SUBJECT: Forwards response to request for addl info in support of review of proposed Tech Specs for upgraded ECCW sys.

Subject: Oconee Nuclear Station
Docket Nos. 50-269, -270, -287
Proposed Revision to Technical Specifications
for the Upgraded ECCW System
Technical Specification Change # 96-09
Supplemental Information Letter #5

Figure 1 Typical Hoffman FS Cabinet

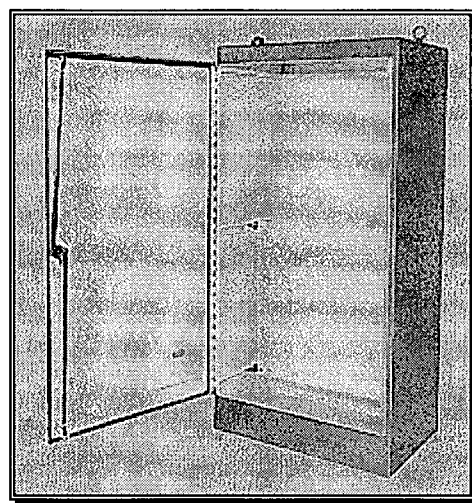
Regarding to your April 6, 1998, response to Question Number 2 concerning the new electrical cabinets, please provide the following information:

1. Physical dimensions of each new cabinet, single-bay or multi-bay,
2. Cabinet Amplification factors used for each cabinet,

Cabinets 1ESV1 and 2ESV1 are 60" tall x 36" wide x 24" deep. They are single bay cabinets with a single door similar to the cabinet shown in Figure 1. An amplification factor of 4.5 (GIP, Rev 2, Corrected 6/28/91, Table 6-2) was used for these cabinets. The cabinets are mounted in the Auxiliary Building, therefore, the floor spectra is also multiplied by 1.5 for median centered in-structure spectra (GIP Table 6-1). This results in a total in-cabinet amplification factor of $4.5 \times 1.5 = 6.75$.
